In re Applications of)	MM DOCKET NO. <u>92-310</u>
ROBERT M. RICHMOND)	File No. BPH-910703MD
BARBARA BRINDISI)	File No. BPH-910703MI
LAURYN BROADCASTING CORPORATION)	File No. BPH-910703MJ
For Construction Permit for a)	
New FM Station on Channel 265A)	
in Beaumont, California)	
and)	
KAY SADLIER-GILL)	File No. BPH-910611IF
For Modification of Facilities)	
for Station KATY-FM, Idyllwild,)	
California)

PETITION FOR LEAVE TO AMEND

RE: KATY-FM

**ENGINEERING EXHIBITS
IN SUPPORT OF MINOR
MODIFICATION OF APPLICATION
FOR CONSTRUCTION PERMIT**

EXHIBIT E-4
7.5 MINUTE TOPOGRAPHIC SITE MAP

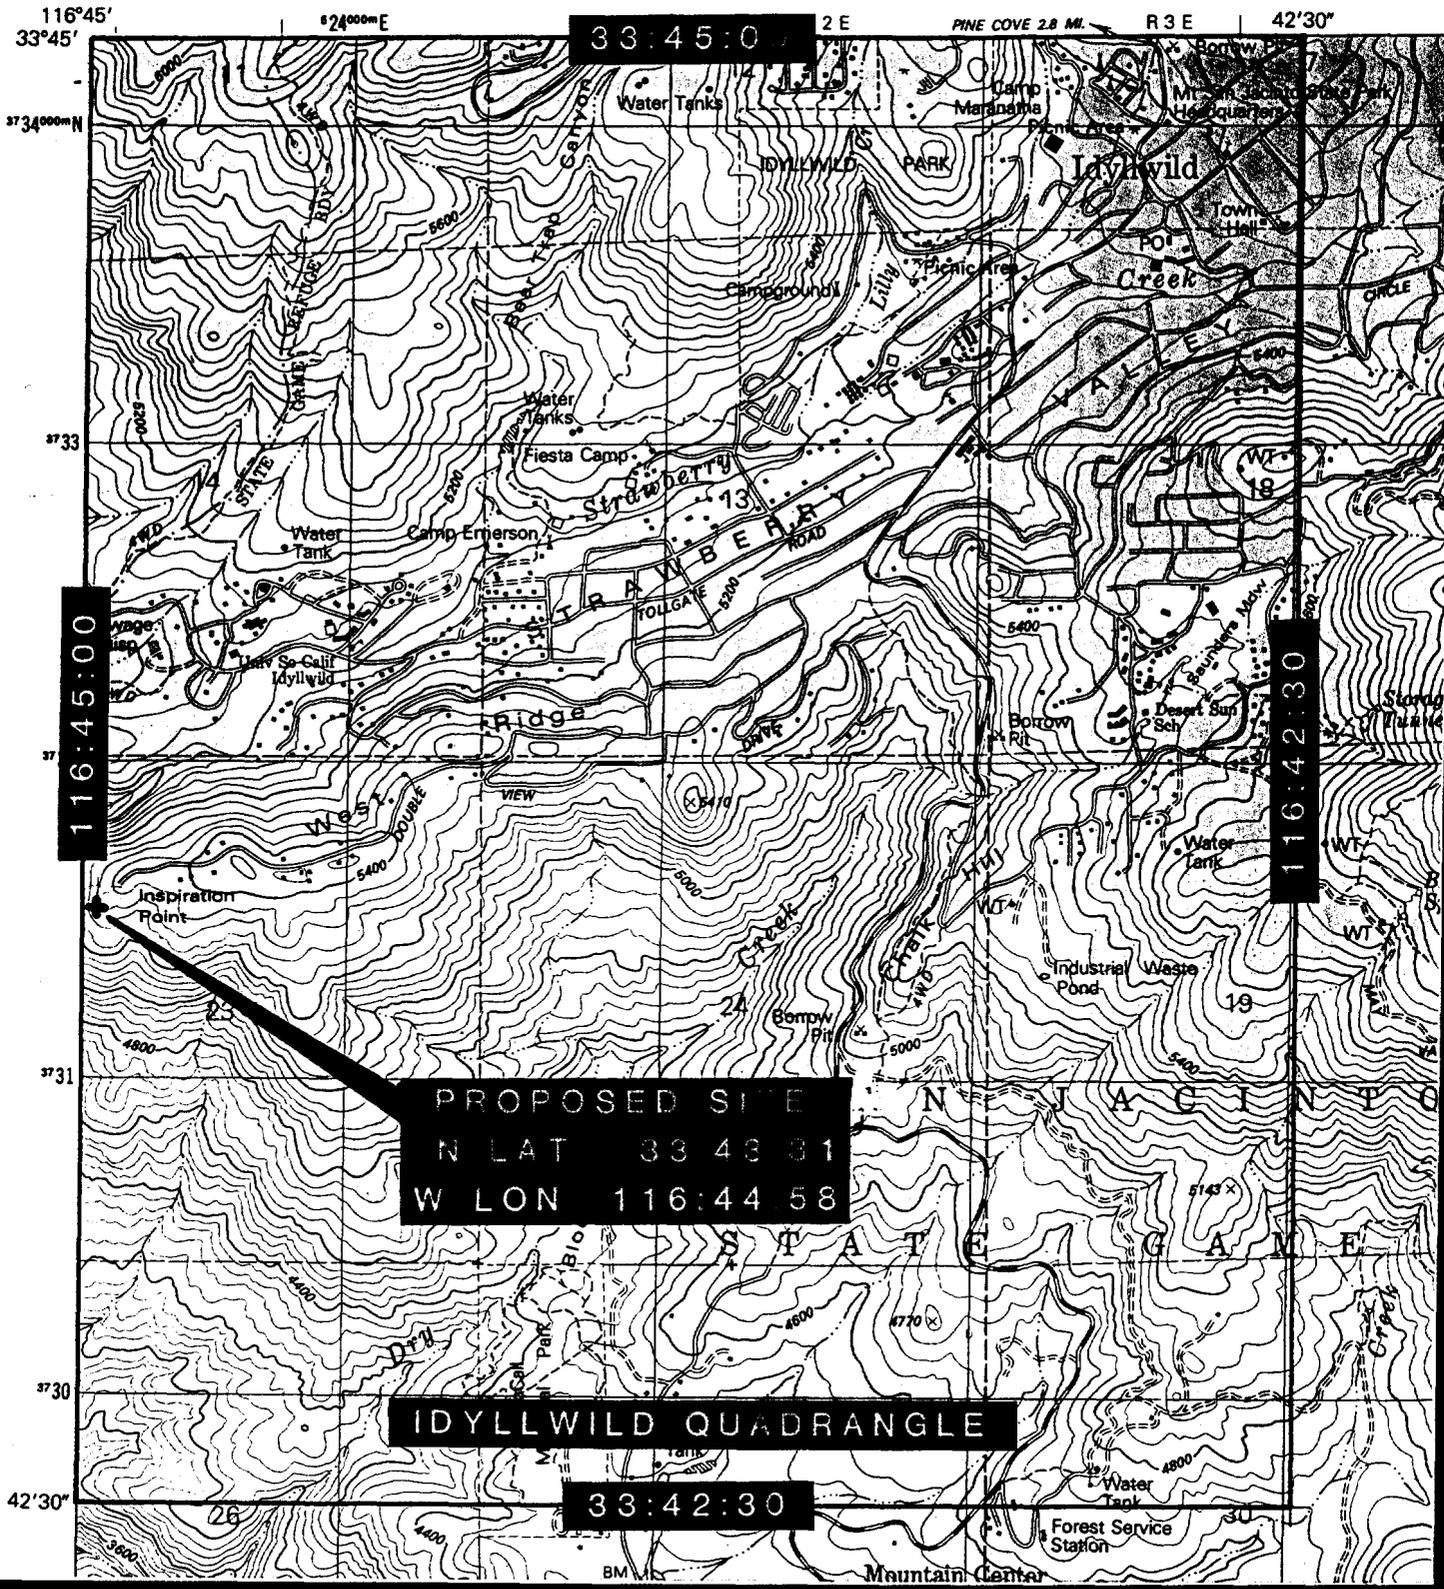
Please amend my application to modify the facilities of Station KATY-FM, Idyllwild, California, to include the attached revised engineering materials. These materials show a slight relocation of my transmitter site. In all other respects, the technical and non-technical portions of my application are unchanged. Dated this 16th day of February, 1993.

This application proposes to change the North Latitude by 2 seconds and to eliminate top beacon.
(if more space is required, continue on a separate sheet.)

PROPOSED SITE
 N LAT 33 43 31
 W LON 116:44 58
